Archaeological Overview Assessment
RPA 1716: Terra Nova National Park Utility Systems Recapitalization
Terra Nova National Park (Newfoundland and Labrador)
Funding: To Be Determined

Prepared By: J. Higdon, Archaeologist, IACH Directorate
Date: May 15, 2019

Figure 15: Loop A 1 Road Watermain. Yellow lines highlight proposed excavations in undisturbed locations of moderate archaeological potential. (Crandall 2019d: CW27).

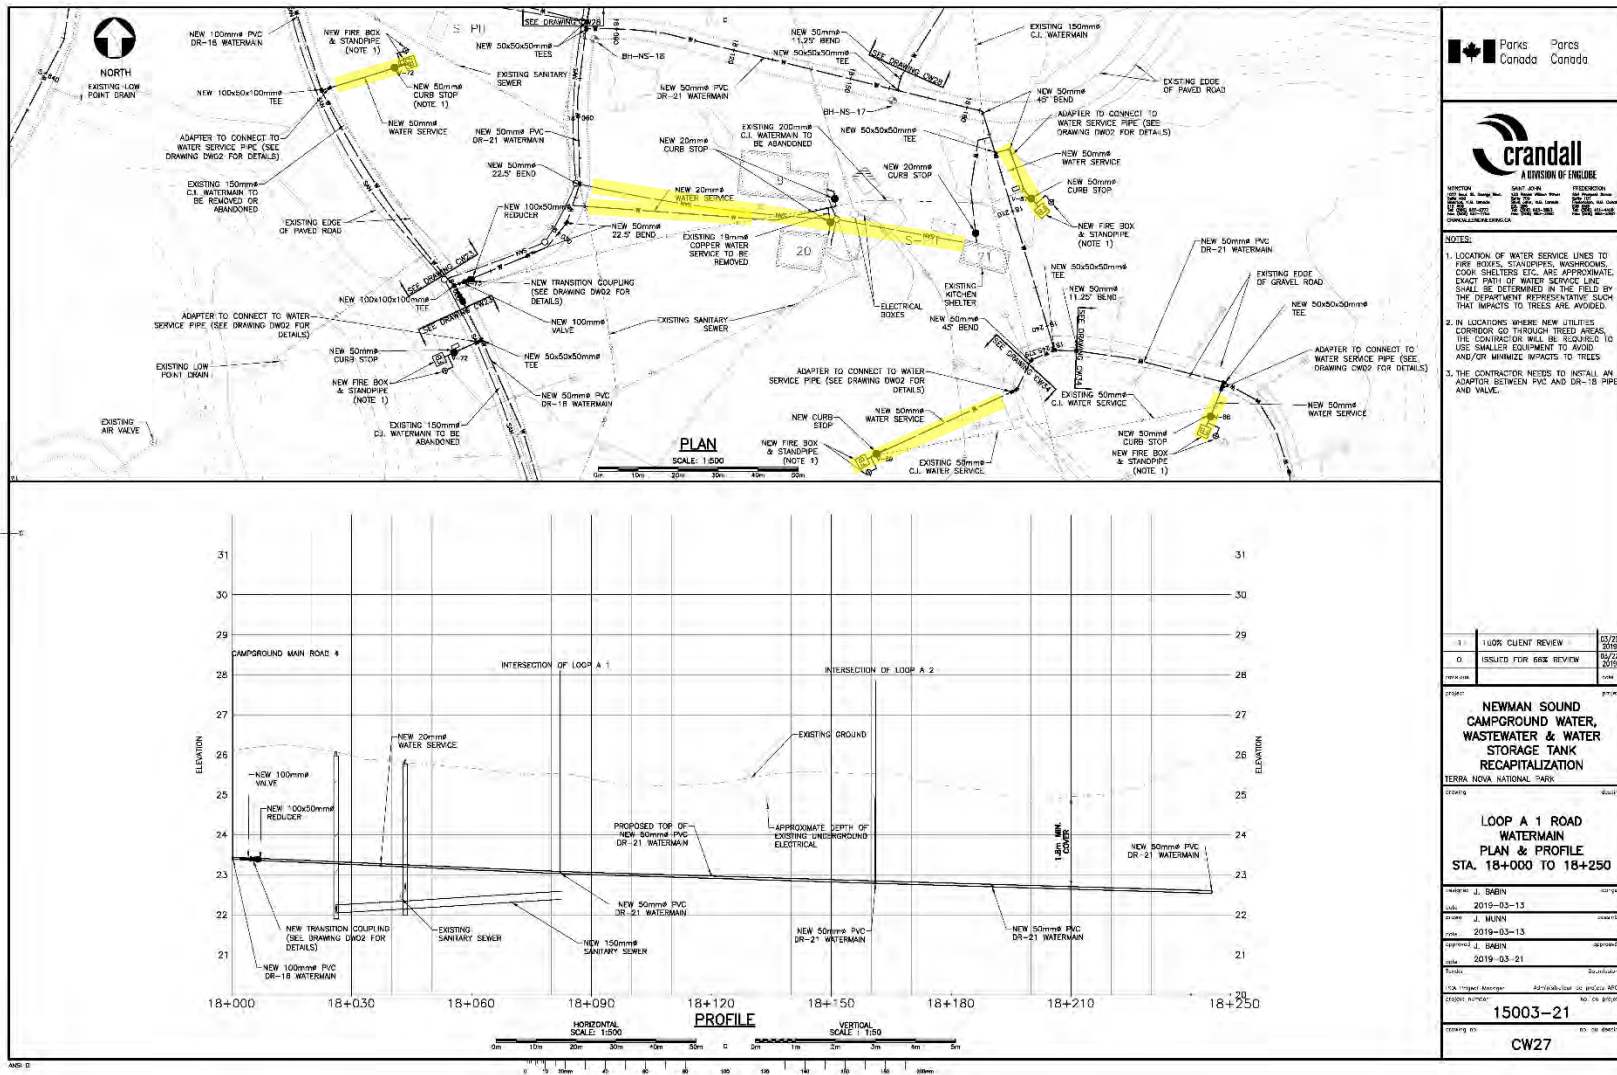
- CW23 - Watermain and Firebox installation (Table 4, Figure 13).
- CW27 - Watermain and firebox installation (Table 4, Figure 15).
- CW28 - Watermain / water service & Fire Box (Table 4, Figure 16).
- CW33 - Watermain / water service, sanitation line, power line and fireboxes (Table 4, Figure 17).
- CW34 - Watermain / water service, sanitation line and fireboxes (Table 4, Figure 18).

Figure 16: Loop A 2 Road Watermain. Yellow lines highlight proposed excavations in undisturbed locations of moderate archaeological potential. (Crandall 2019d: CW28).

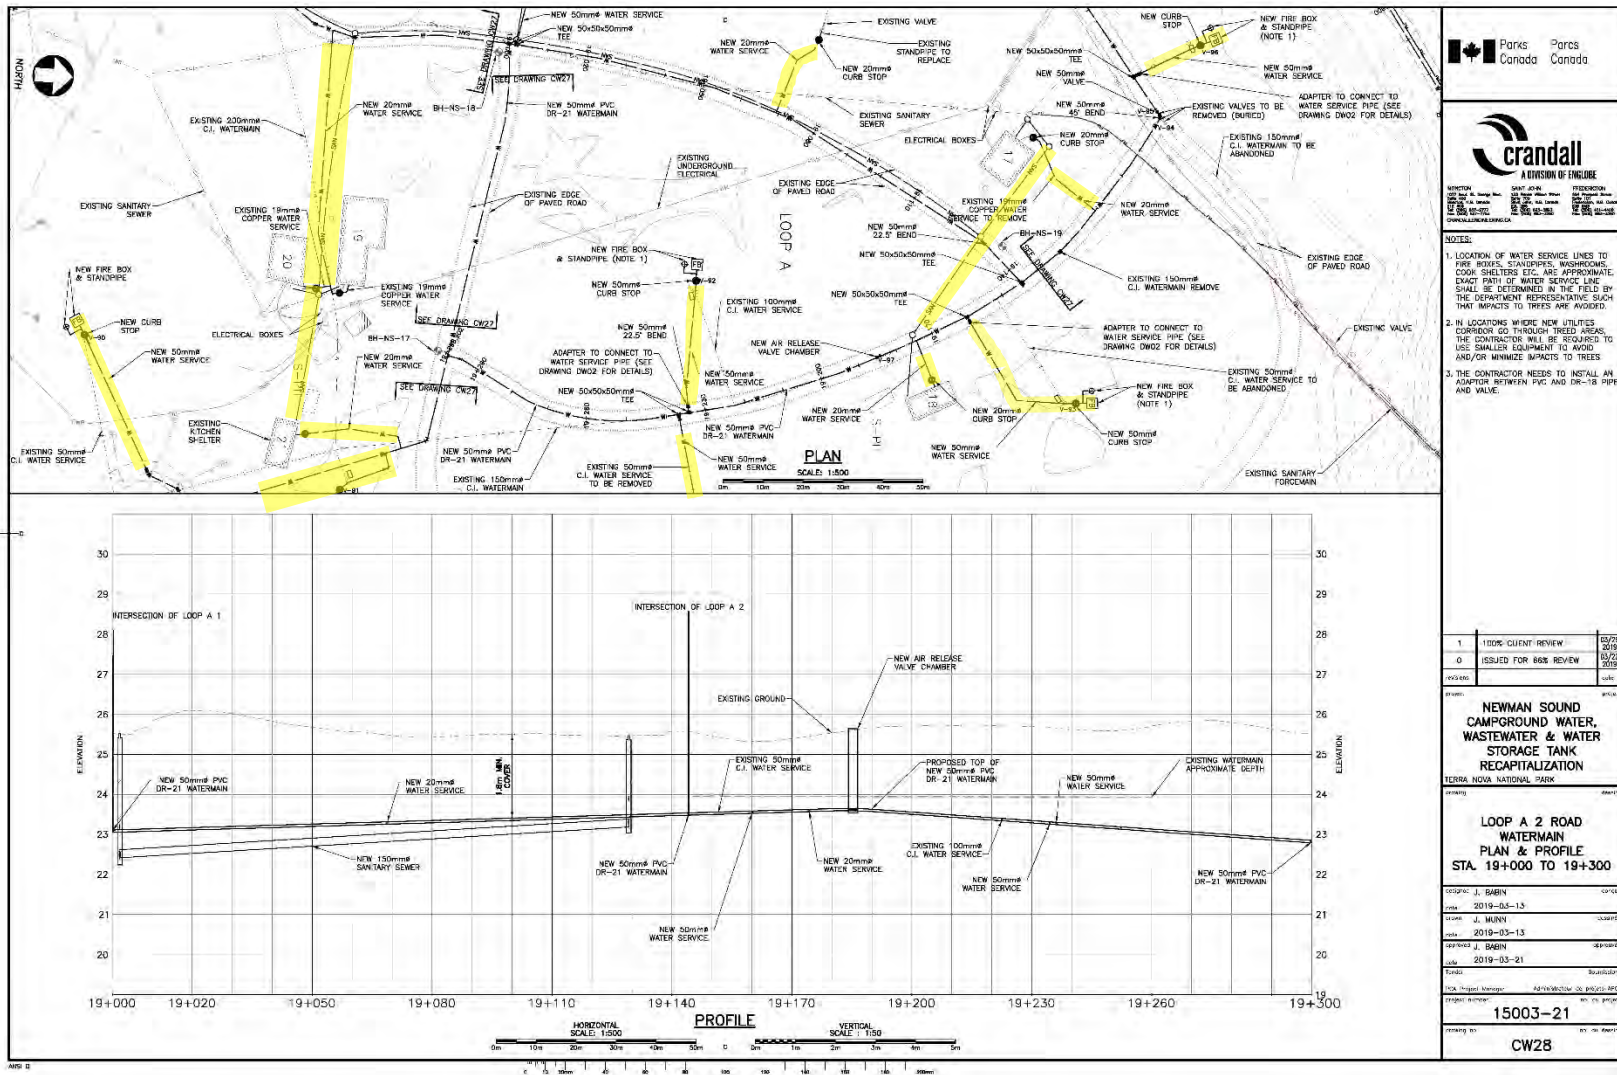
CW28	Watermain/water service (3 x 30m, 3 x 40m, 50m, 100m) & Fire Box; 4 Fireboxes (Figure 16).	Moderate archaeological potential. ~250m west of Newman Sound	Yes. Site Visit to see if judgemental test pitting is required.
CW33	Watermain/water service (2x 10m, 20m, 30m, 40m, 60m), Sanitation line (30m), Power line (20m) & 6 Fire boxes (Figure 17).	Moderate archaeological potential. ~250m west of Newman Sound	Yes. Site Visit to see if judgemental test pitting is required.
CW34	Watermain/water service (20m, 2 x 30m, 3 x 50m, 60m), Sanitation line (90m) & 4 fire boxes (Figure 18).	Moderate archaeological potential. Less than 250m west of Newman Sound.	Yes. Site Visit to see if judgemental test pitting is required.

Figure 20: Sanitary Sewer Plan and Profile STA.0+000 to 0+300 with red rectangles showing project areas that may be located within previously undisturbed areas of the park (Crandall 2019a).

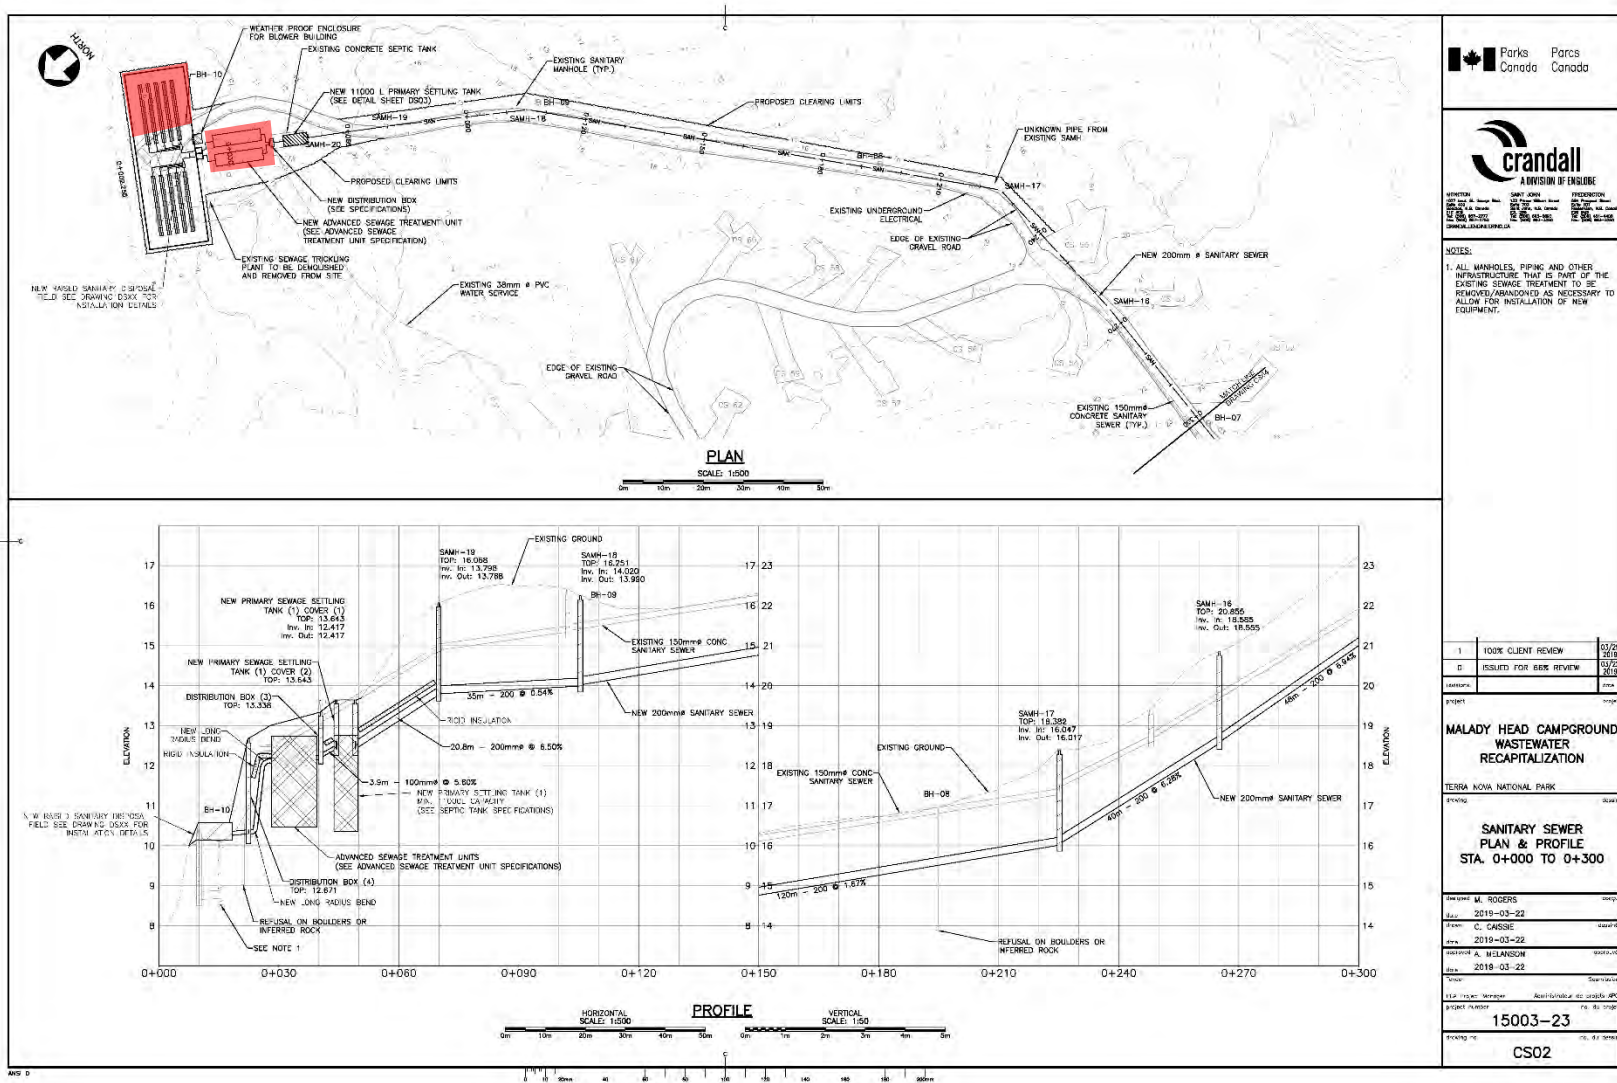
A New Raised Sanitary Disposal Field is proposed for the northeastern extent of the Malady Head Campground Area (Figure 19 & 20). Located approximately 220 m away from the ocean, the proposed disposal field will be approximately 20m x 50m and excavated at a depth of 2-3 meters. A review of the plans suggests that the southern two thirds of the project footprint overlays the existing sewage trickling

plant and parking area. The profile of the project footprint, detailing existing ground surface and extent of excavations indicates that this disposal field will be built along an existing slope. While this area is of low archaeological potential, it will involve excavation in previously undisturbed areas. **An Archaeological Impact Assessment in the form of a site visit to determine if judgmental test pitting is required.**

- CS02 - New raised sanitary disposal field at northern eastern extent of campground area (Section 3.4.2, Figure 20).
- CS06 - New septic field associated with existing kitchen shelter (Section 3.4.3, Figure 21).

Figure 21: Sanitary Sewer Plan and Profile STA.4+000 to 4+070 & Kitchen Shelter Septic System. Red rectangles showing project areas that may be located within previously undisturbed areas of the park (Crandall 2019a).

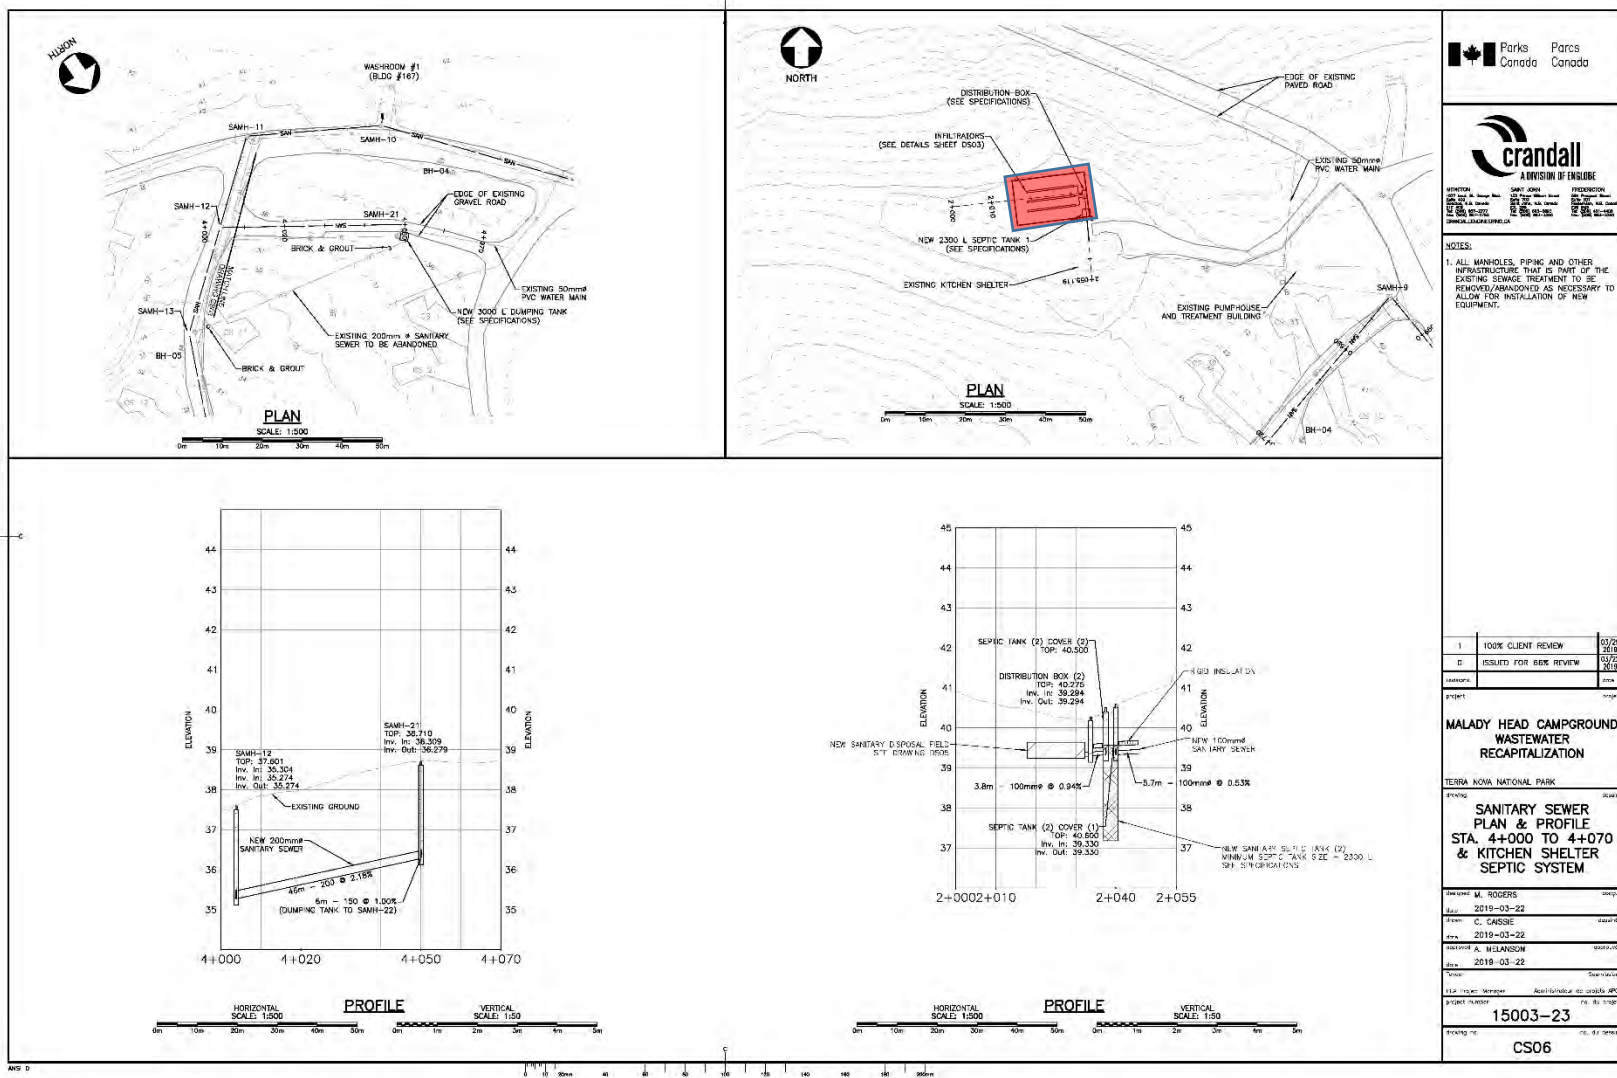
Drawing CS06 shows the proposed location of a new 2300L septic tank and related system to the north of the existing kitchen shelter (Figure 21). Excavation associated with the septic tank and associated infiltrators and distribution box will impact an area approximately 10m x 20m and 2-3m deep. While this area is of low archaeological potential, it will involve excavation in previously undisturbed areas. **An Archaeological Impact Assessment in the form of a site visit to determine if judgmental test pitting is required.**

Figure 22: Proposed Washroom Burnt Point Septic System (Crandall 2019a)..

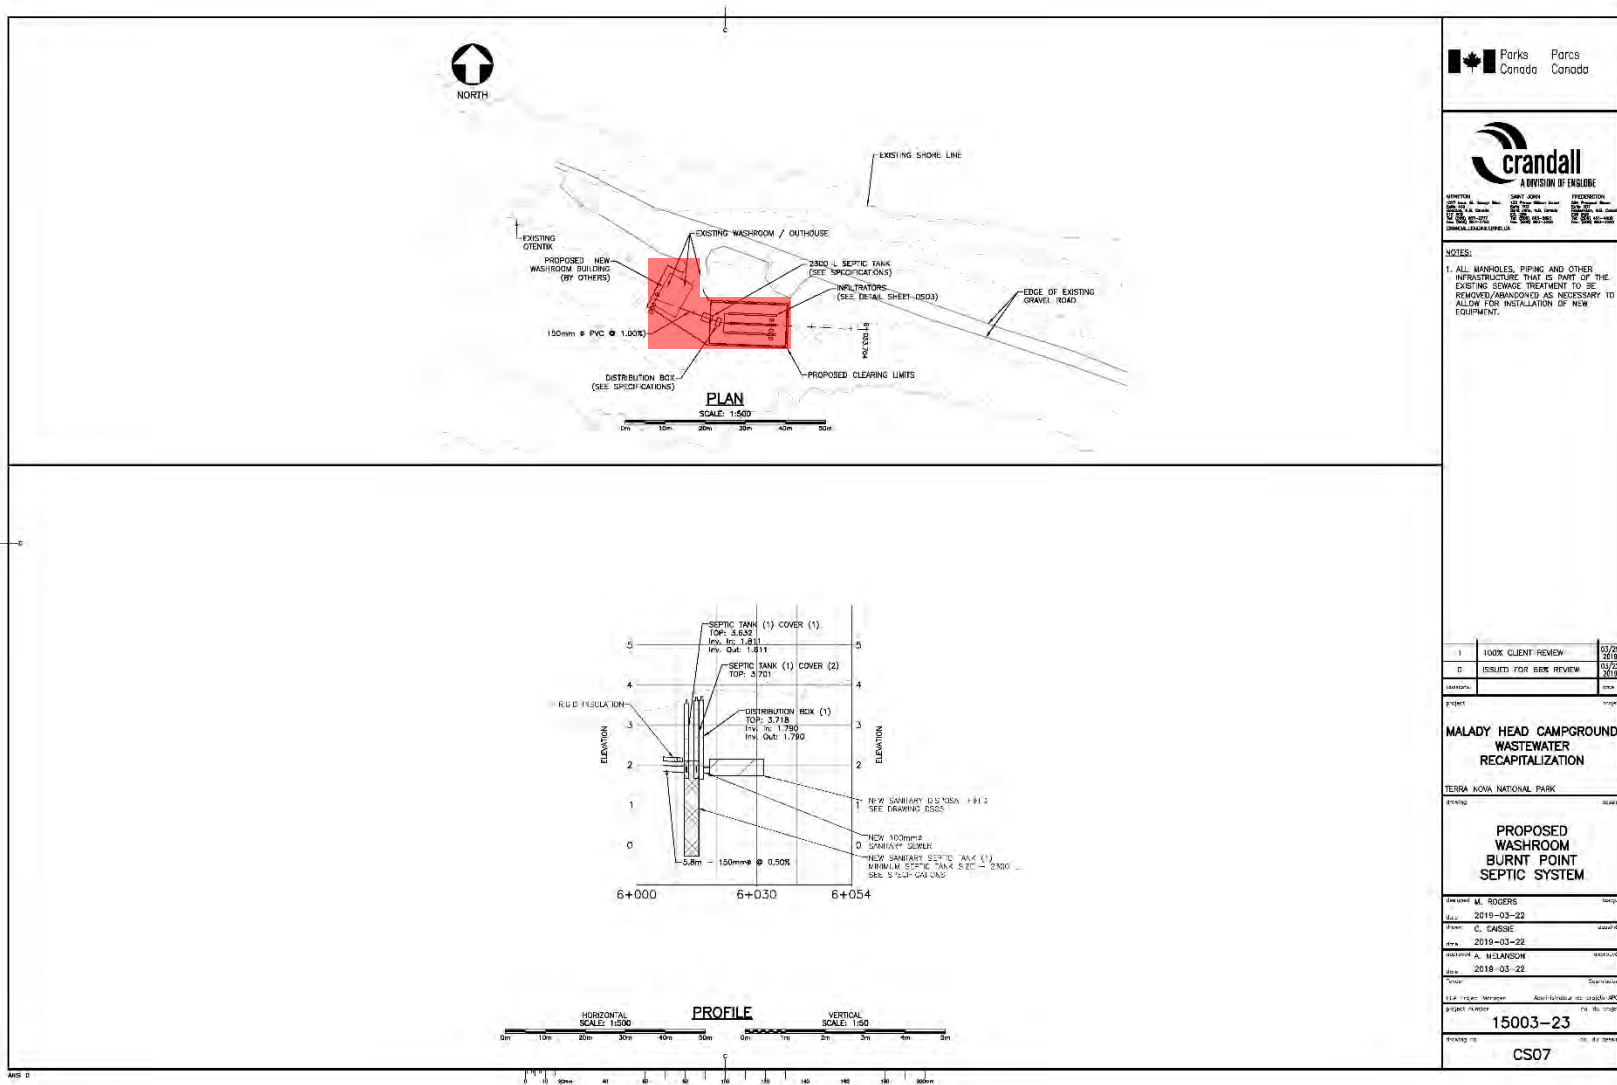
Located within 40m of the current beach, this portion of the project includes the removal of existing washroom / outhouse buildings and the installation of a new washroom building and associated septic tank system (Figure 22). While the specific dimensions of the washroom facility have not been given, the drawings show an area approximately 10m x 10m. A sewage pipe connects the facility to a 2300L septic tank and associated 10m x 20m septic field containing infiltrators and a distribution box. Excavations for the septic tank and infiltrators involve excavations at depths of 2-3m.

The general area associated with the proposed new washroom facilities and associated septic tank system is of **high archaeological potential**. While the likelihood of locating intact cultural features and deposits in this area may be reduced because of construction associated with existing washroom infrastructure, **an archaeological impact assessment is required to determine if judgemental testing is needed. Also more information about the nature and extent of washroom building is needed to complete this portion of the AOA.**

- **Project:** Malady Head Campground Wastewater Recap Newman Sound ([Crandall2019a](#))
- **Summary:** Installation of new washroom building and septic day at Burnt/Point / Beach Cove Day Use area (Figure 22).
- Project Activities are outlined in Section 3.4.3 and Crandall 2019, Sheet CS07 (Figure 22).
- **More information about the nature and extent of washroom building is needed to complete this portion of the AOA.**
